Video Products Technical Bulletin 30-2002-169

SUBJECT: **COLOR CHANGE AT LOW LUMINANCE**

MODEL: ***BVM-F24***
BVM-F24A
BVM-F24U

Figure 1

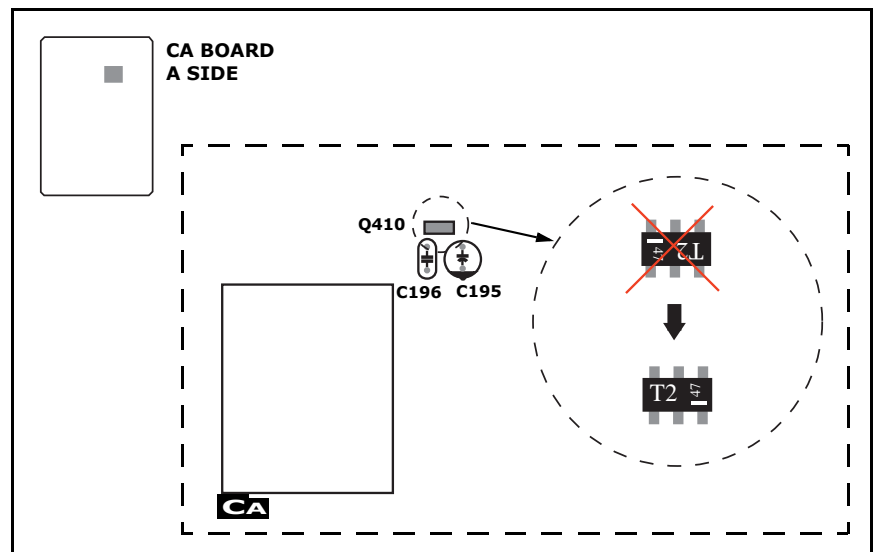
When luminance is low (less than 10 IRE), the color becomes bluish. Even if 100 IRE and 20 IRE are adjusted, the picture does not improve. To correct this condition, perform the following procedure.

CA Board Side A, Zone E-6

On the CA board, replace Q410. Mount the new part as shown in Figure 1.

| Part No. | Description | Qty. |
|--------------|-------------|------|
| 8-729-925-42 | IMT2 | 1 |
